BALL SUBDIVISION

APPLICATION NUMBER 4 DATE September 15, 2016

APPLICANT Ball Subdivision

REQUEST Subdivision

BALL SUBDIVISION

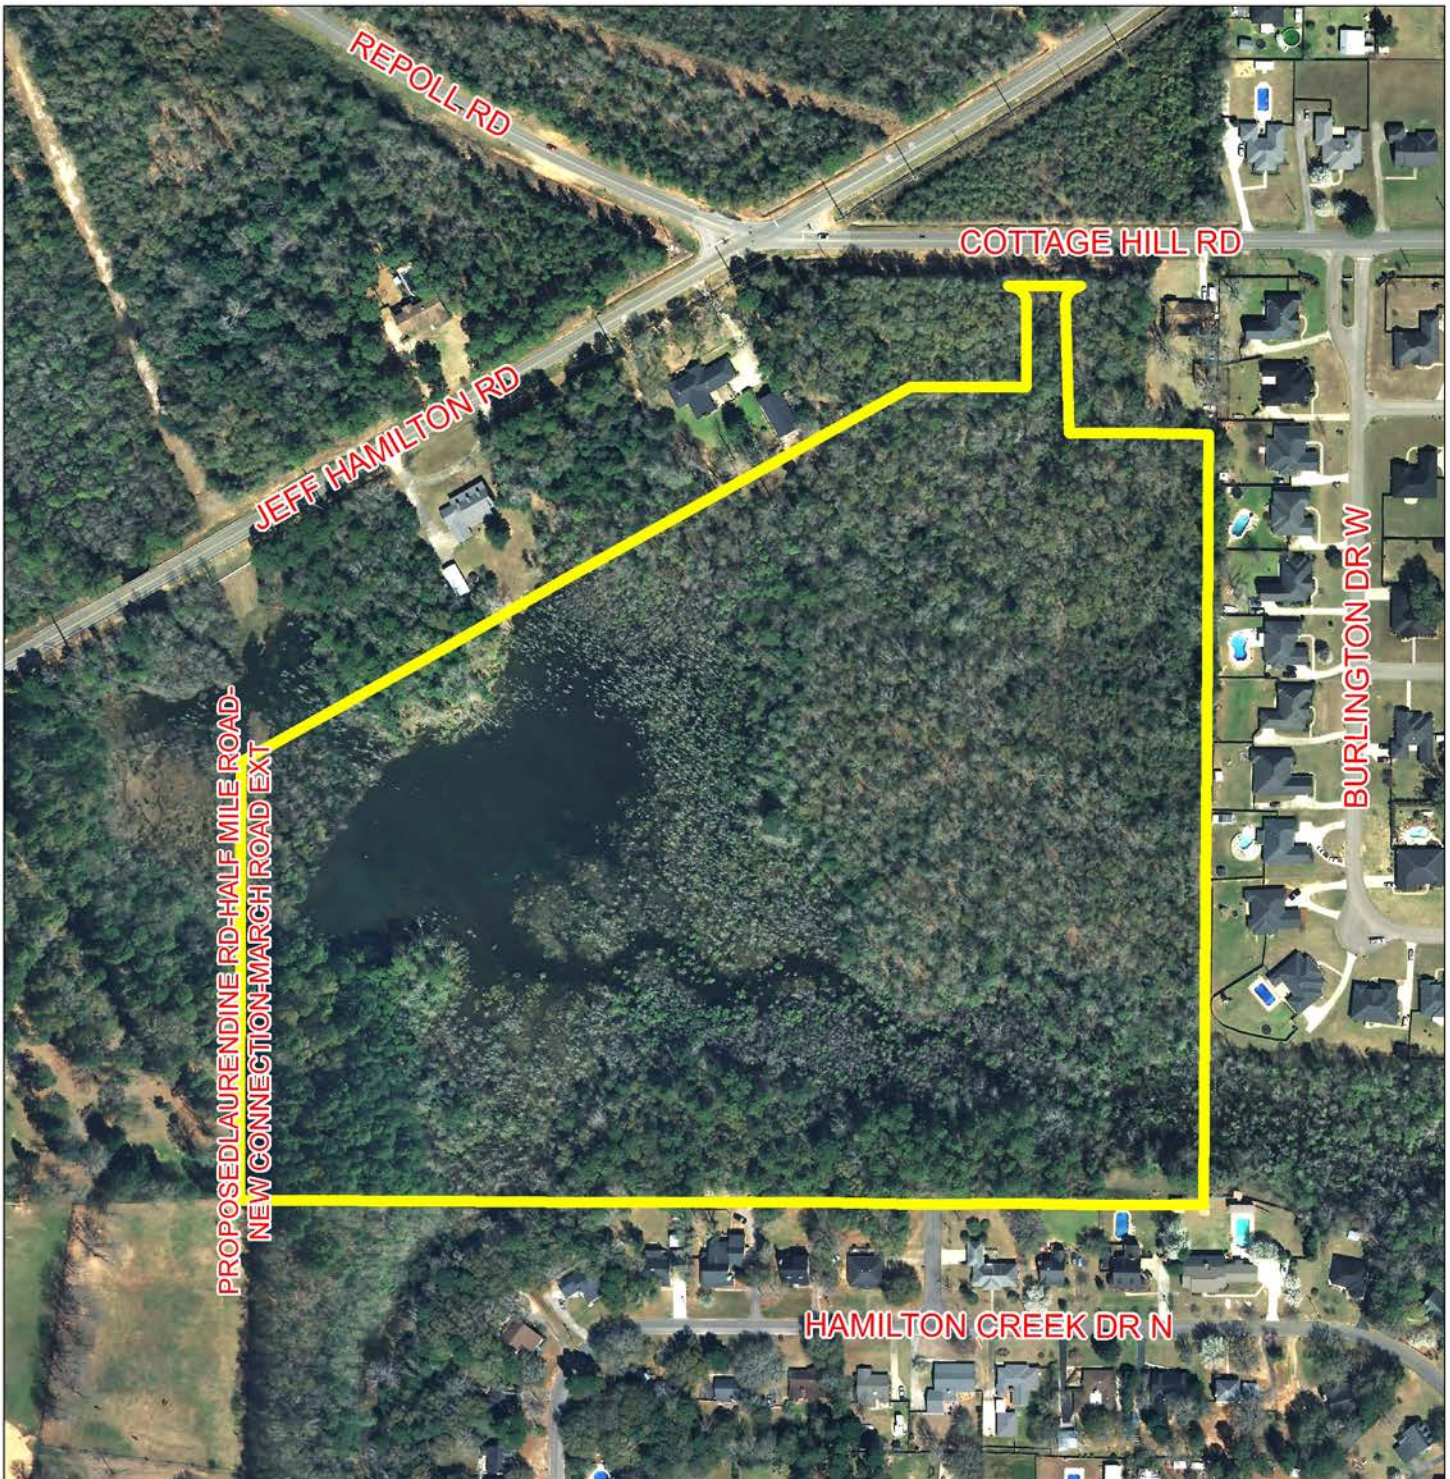
The unopened public street stub from Cottage Hill Road is proposed to be combined with the larger internal parcel to serve as a driveway access point. However, as it is public right-of-way, it cannot be included as part of the Subdivision until vacated. Vacation was attempted by the property owner at the Commission's July 17th meeting and heldover until the August 18th meeting to allow the owner to submit a Subdivision application in order to combine the larger parcel and the stub. The Subdivision application was not submitted and the Vacation was denied. Now that the Subdivision application is present, it indicates the proposed combining of the larger parcel and the street stub. Thus, if the Subdivision is approved, it should be contingent on the vacation of the public street stub from Cottage Hill Road prior to signing the Final Plat.

25' front setback should be blocked-out on the Final Plat as measured from the South terminus of the current street stub. Along the West side of the site, the property line is the center of the proposed new road. Therefore, the future right-of-way line should be illustrated 50' from the West property line and the front setback line should be measured 25' in from the future right-of-way line, or 75' from the current West boundary of the site. To the South the North terminus of Scenic Park Drive North stubs against the site. A 25' minimum building setback line should be blocked-out at this street stub. Also, it appears that two lots of the originally-recorded Cottage Hill Park Subdivision, Unit One, have been acquired as public right-of-way by the County. Therefore, a 25' minimum building setback line should be blocked-out along this area.

As the street stub from Cottage Hill Road is intended to be the access to the site, a note should be placed on the Final Plat stating that the lot is limited to one curb cut to Cottage Hill Road, with the size, location and design to be approved by Mobile County Engineering and conform to AASHTO standards.

The proposed lots meet the minimum size requirements of the Subdivision Regulations. The plat should be revised to label the lot with its size in both square feet and acres, or a table should be furnished on the Final Plat providing the same information.

- 1) completion of the Vacation process for the public street stub to Cottage Hill Road prior to signing the Final Plat;
- 2) revision of the plat to indicate a 25' minimum building setback block-out as measured from the South terminus of the current street stub;
- 3) revision of the plat to indicate the future right-of-way line of Laurendine Road-Half Mile Road-New Connection-March Road Extension 50' in from the West property line and a minimum building setback line 75' in from the West property line;
- 4) revision of the plat to illustrate a 25' minimum building setback line blocked-out from the North terminus of Scenic Park Drive North;
- 5) revision of the plat to illustrate a 25' minimum building setback line blocked-out as measured from the unopened public right-of-way between Lots 12 and 15, Cottage Hill Park Subdivision, Unit One;

- 6) placement of a note on the Final Plat stating that the lot is limited to one curb cut to Cottage Hill Road via the vacated street stub, with the size location and design to be approved by Mobile County Engineering and conform to AASHTO standards;

- 7) revision of the plat to label the lot with its size in both square feet and acres, or the furnishing of a table on the Final Plat providing the same information;
